From: Stephen Brandes Architect
Sent: 09 September 2024 16:24
To: Planning
Subject: FAO Blythe Smith application 2024/3126/P
Attachments: vale house plans 2024 sb comment.PDF

Client	Mr Adnan Karim
Site	Vale House , Vale of Health London NW3 1AX

Project	Refurbishment Works
Drawing Title	Proposed Floor Plans

Proposed Roof Plan

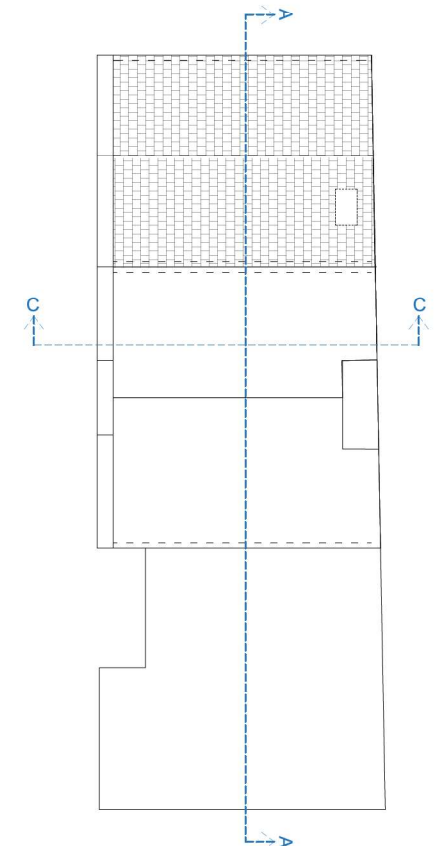
We have no objection to the proposals as submitted, however in regard to the roof terrace it is important to note that there has been trellis screening in place above the parapet walls adjoining Vale Lodge, as marked up on the attached plans, which has been beneficial in screening overlooking and providing privacy from both sides. The trellis had decayed over years of neglect and, whilst the house was unoccupied, had fallen into such disrepair it was in danger of falling into our property, so we had it taken down.

We have already drawn the applicant's attention to this and believe they are in agreement the trellis should be reinstated as being beneficial to both parties. As the trellis had been present for many years (at least since 1995 to my own knowledge) there should be no question of planning or listed building approval, we would simply request that the trellis be added to the drawings.
